Broadcast Products Technical Bulletin 20-2005-042R

SUBJECT: REPLACE H. CENT COIL

MODEL: ***BVM-D14H5E***
BVM-D14H5U
PVM-14L5
PVM-20L5
PVM-D14L5A
PVM-D20L5A

Figure 1

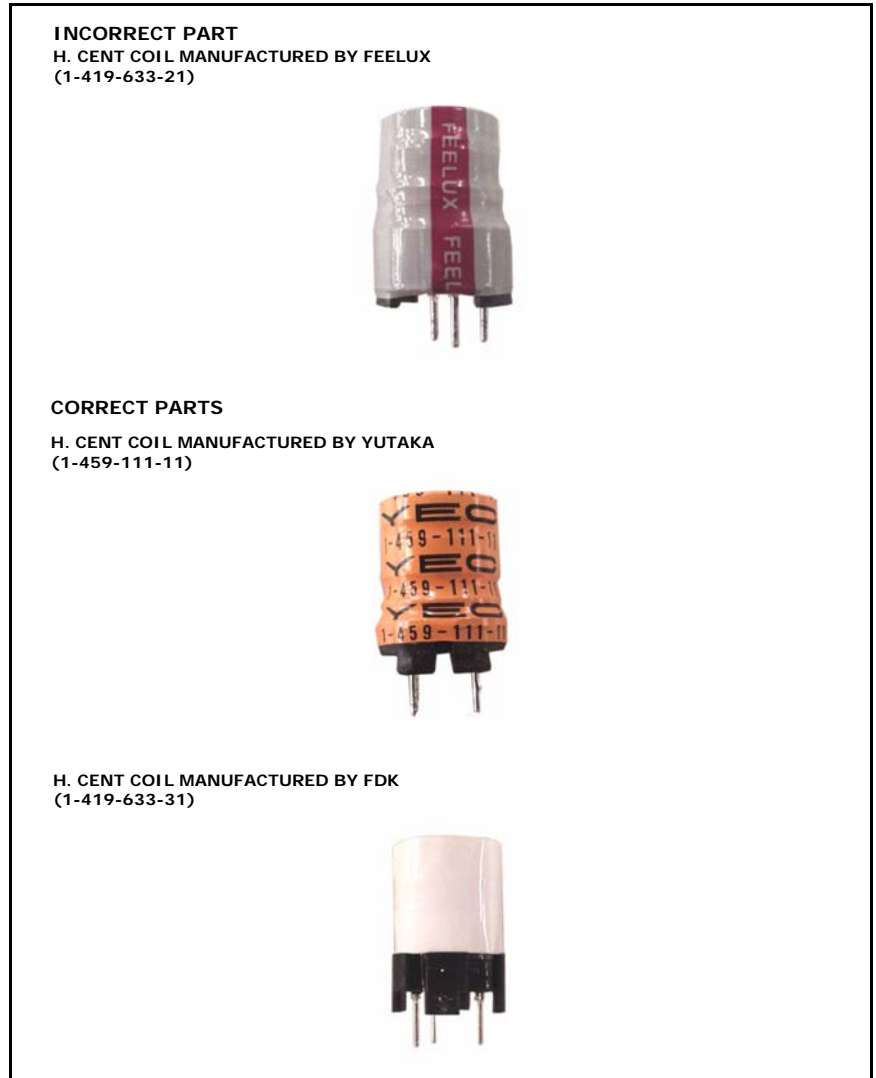
1. Replace the following H. CENT coil (manufactured by FEELUX, gray) with an H.CENT coil manufactured by FDK.

NOTE: H. CENT coils manufactured by Yutaka Corp (orange) or by FDK (white) do not need to be replaced. (See Figure 1.)
